**Economic and Social Council**Distr.: General
11 April 2013

Economic Commission for Europe**Inland Transport Committee****World Forum for Harmonization of Vehicle Regulations****Working Party on Brakes and Running Gear****160th session**

**1958 Agreement – Consideration of pending proposals
for amendments to existing Regulations submitted by the
Working Parties subsidiary to WP.29****Proposal for Supplement 5 to the 02 series of amendments to
Regulation No. 117 (Tyres, rolling resistance, rolling noise
and wet grip)****Submitted by the Working Party on Brakes and Running Gear***

Figure 1
Nomenclature explanation related to grip index of the tyre

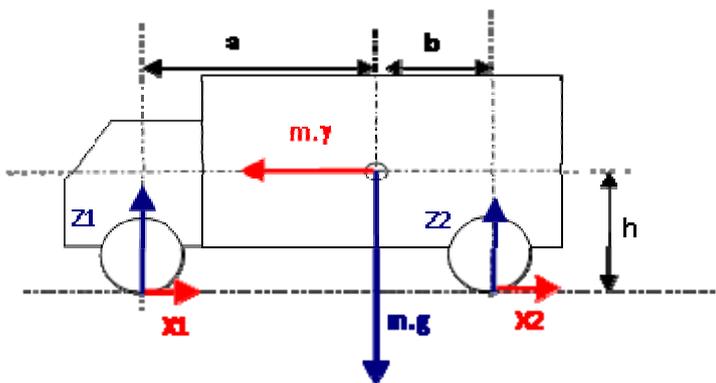
Configuration C1: candidate tyres on both axles	Wet Grip index = $\frac{BFC(T)}{BFC(R)}$
---	--

Configuration C2: candidate tyres on front axle and reference tyres on rear axle	$\text{Worst Grip Index} = \frac{BFC(F) \cdot [a + b + h \cdot BFC(R)] - a \cdot BFC(R)}{BFC(R) \cdot [b + h \cdot BFC(F)]}$
Configuration C3: reference tyres on front axle and candidate tyres on rear axle	$\text{Worst Grip Index} = \frac{BFC(F) \cdot [-a - b + h \cdot BFC(R)] + b \cdot BFC(R)}{BFC(R) \cdot [-a + h \cdot BFC(F)]}$

- "G": centre of gravity of the loaded vehicle
- "m": mass (in kilograms) of the loaded vehicle
- "a": horizontal distance between front axle and centre of gravity of the loaded vehicle (m)
- "b": horizontal distance between rear axle and centre of gravity of the loaded vehicle
- "h": vertical distance between ground level and centre of gravity of the loaded vehicle (m).
- N.B. When "h" is not precisely known, these worst case values shall apply: 1,2 for configuration C2, and 1,5 for configuration C3
- "γ" loaded vehicle acceleration (m·s⁻²)
- "g" acceleration due to the gravity (m·s⁻²)
- "X1" longitudinal (X-direction) reaction of the front tyre on the road
- "X2" longitudinal (X-direction) reaction of the rear tyre on the road
- "Z1" normal (Z-direction) reaction of the front tyre on the road
- "Z2" normal (Z-direction) reaction of the rear tyre on the road
